Office Action Summary	Application No. 10/579,200	Applicant(s) LANDUYT, CHRISTOPHE VAN	
	Examiner RACHEL T. YOUNG	Art Unit 3771

DETAILED ACTION

4. Claims 1-8 and 10 are rejected under 35 U.S.C. 103(a) as being unpatentable over Persson (2002/0156527) in view of Geertsema (6,439,233).

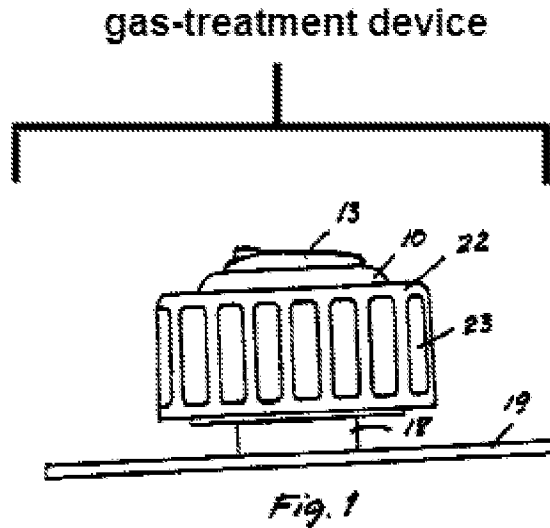
As to claim 1, Persson discloses a gas-treatment device (Fig. 1 below) for use with a tracheostomy tube (Page 1, ¶ 23, ll. 22), the device including an elongate housing (10, Fig. 3 is wider than it is tall) for connection to the tube (Page 1, ¶ 23, ll. 17-22) to extend generally transversely of the tube (Fig. 3, 10 extends to both sides of the tube), a gas passage in the housing (11, Fig. 5), a gas-treatment unit (20, 21, 22) mounted with the housing (Fig. 2 and 4), the gas-treatment unit is displaceable by rotation about an axis (Page 2, ¶ 24) from a first position (Fig. 5) (Page 2, ¶ 27) in which gas can flow from the tube through the gas-treatment unit via the gas passage, to a second position (Fig. 4) (Page 2, ¶ 26, ll. 1-6) in which the gas passage is substantially blocked preventing flow of gas out of the machine end of the tracheostomy tube.

As to claims 7-8 and 10, Persson discloses that the gas-treatment unit includes a heat and moisture exchanger element (22, Fig. 1, Page 2, ¶ 25, ll. 1), at opposite ends (Fig. 2), and a tracheostomy tube assembly including a tracheostomy tube (18, Fig. 2, Page 2, ¶ 23, ll. 22) and a gas-treatment device (Fig. 1 above) connected at the machine end of the tube (18, Page 2, ¶ 23, ll. 17-22).
